**KEIZER PLANNING DEPARTMENT
NOTICE OF DECISION
Partition Case 2023-12**

The following report reviews a land use application to divide an existing parcel totaling approximately 16,160 square feet into two parcels comprised of approximately 7,000 square feet (Parcel 1) and approximately 6,600 square feet (Parcel 2). The proposal also includes a major variance request to reduce the minimum required setback from the existing home to the private access easement. Currently, the property is developed with a single-family dwelling and accessory dwelling unit (ADU). (Exhibit 1)

Site: 527 Dearborn Avenue N. Keizer OR 97303	Drawing: 1	Project: 527 Partition	Drawn: Site Plan	Notes:	Michael Le 770 Moonflower St NE Salem Oregon 97301
Title: Partition of 527 and 525 Parcels	Scale: 1" : 10'	Date: 08/07/2023	Rev: A

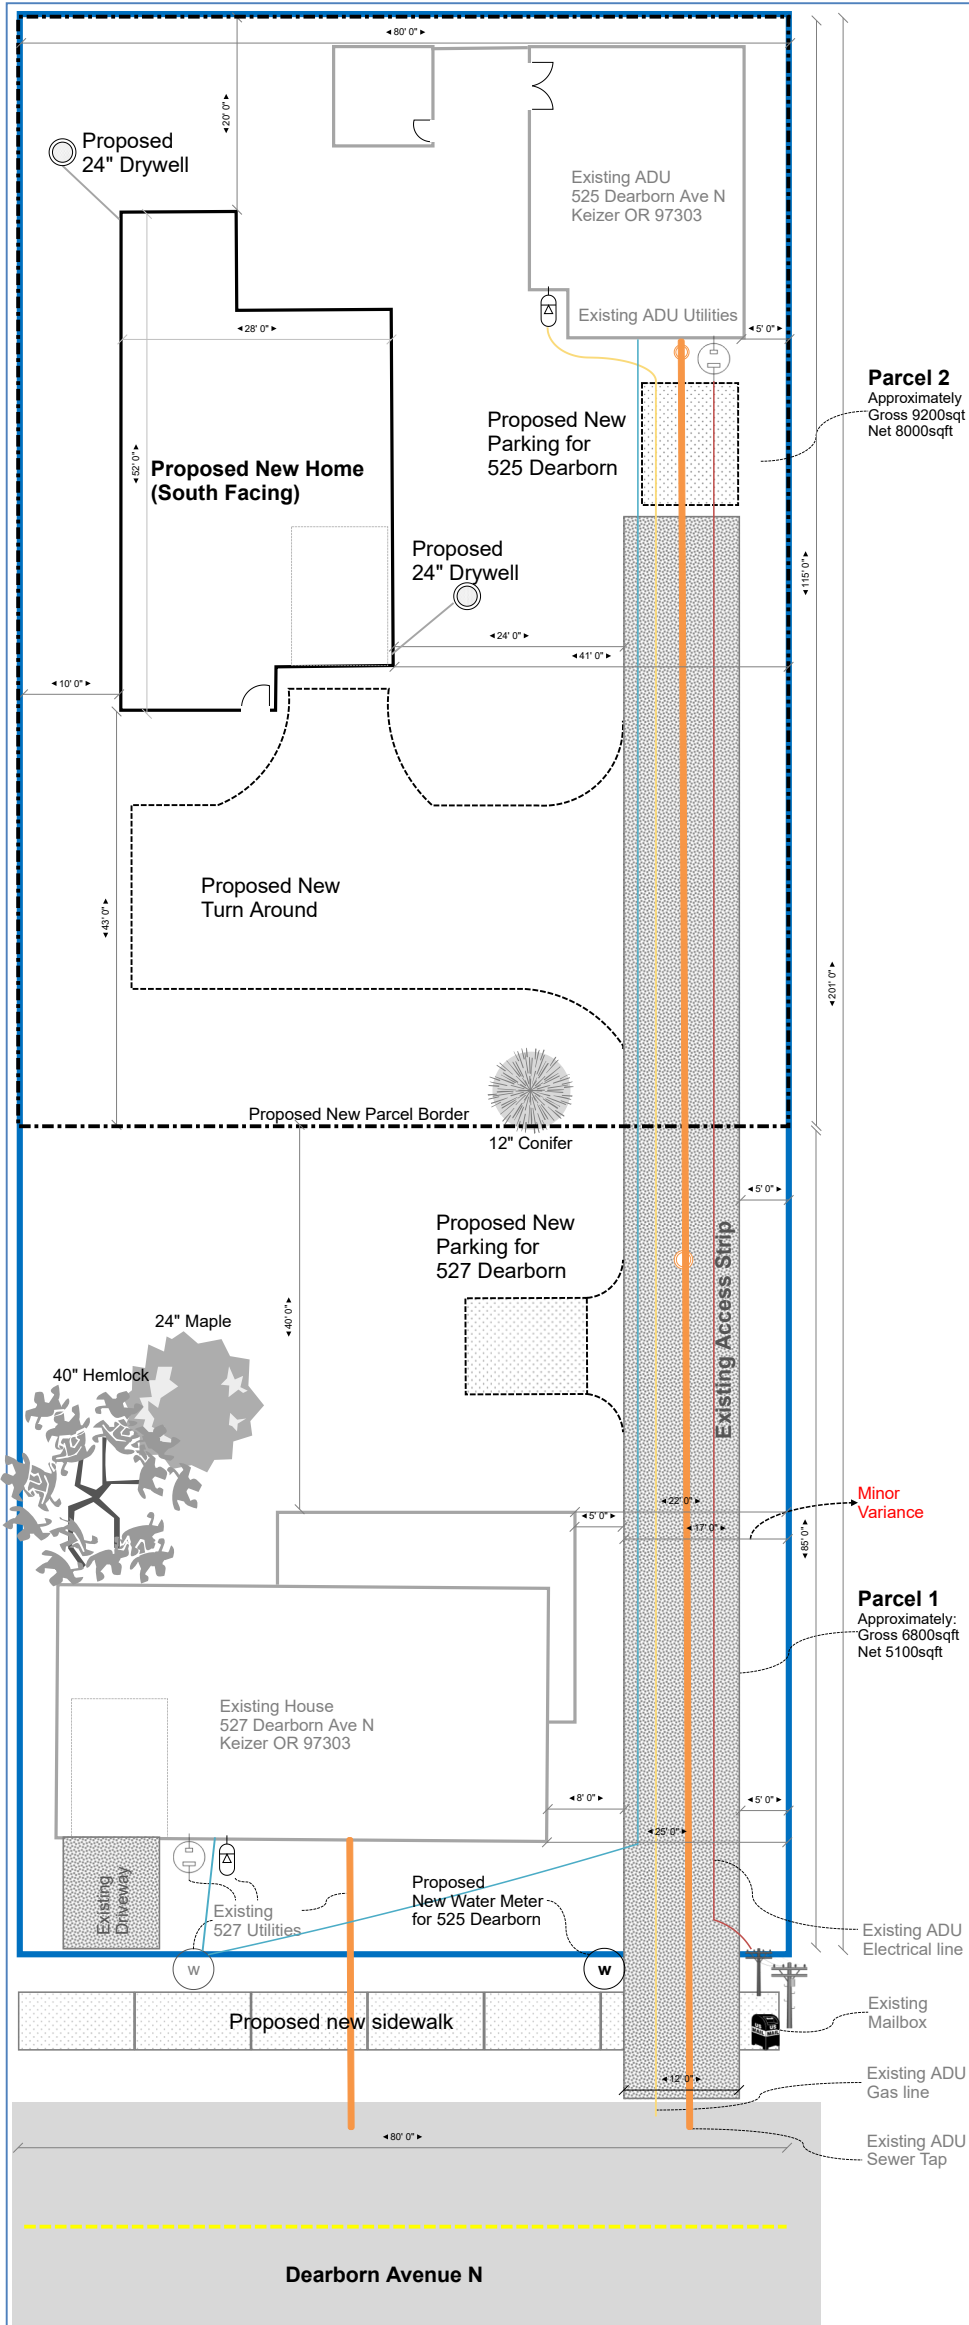
The RS zone also regulates setback requirements in the dimensional standards section of the development code. The minimum rear-yard setback required for a one-story home is 14'. The existing one-story home on Parcel 1 will need to demonstrate the minimum rear-yard setbacks will be met with the new created Parcel 2. A site plan, prepared by a licensed engineer or surveyor and submitted to the City of Keizer Planning Department demonstrating the existing dwelling on Parcel 1 meets the minimum rear setback requirement of the RS zone for a one-story dwelling will be placed as a condition of approval. With this condition, staff finds this request can satisfy this criterion.

Width: A 20' wide easement, not to exceed 300' in length, with paved width of 16' is required for private access easements serving two or more dwelling units. In addition, the RS zone requires a 5' setback from the edge of an access easement to a structure. The applicant has submitted an application for a major variance to this setback requirement reducing the setback to 2'. No modification to the access width is requested. This variance request will be reviewed later in this report.

Turn-around: The KDC requires a turn-around for access easements serving two or more dwelling units. The access easement is proposed to serve both lots, therefore a turn-around is required. The applicant has submitted a site plan (Exhibit 1) that shows a turn-around located on Parcel 2. This will be reviewed by the City Engineer at the time of plat review to ensure dimensions and turning radius requirements are met.

I have a simple request also I would like to suggest that the proposal drawing does not look to be the correct scale for that property. I have walked that property before the Le's bought it and looked at satellite photos of that property going back to 2016 I suggest you do the same before allowing this to happen. John Hill was a working contractor up till recently and my husband works in the trade and they both say that the drywell for the proposed SFD in the back is too close to the fence. Has that code changed from the 10ft that it was before?

It is not clear in the site plan how the proposed SFD will be positioned regarding front, side and back of the building and the compliance with setback requirements. In addition the city code prohibition of parking in the access easement, including the turnaround, raises concern that adequate parking spaces are provided. It appears that the development code requires 3 parking spaces unless on-street parking is available. Does the turnaround incorporate the required 60' diameter?

- 6. A site plan, prepared by a licensed engineer or surveyor must be submitted to the City of Keizer Planning Department demonstrating the existing dwelling on Parcel 1 meets the minimum rear setback requirement of the RS zone.

- 7. Unless waived in writing by the adjacent property owners, a 6’ sight-obscuring fence, wall, or hedge is required along the east side of the access easement to provide screening to the adjacent property. If waived, documentation must be submitted to the City of Keizer Planning Department.
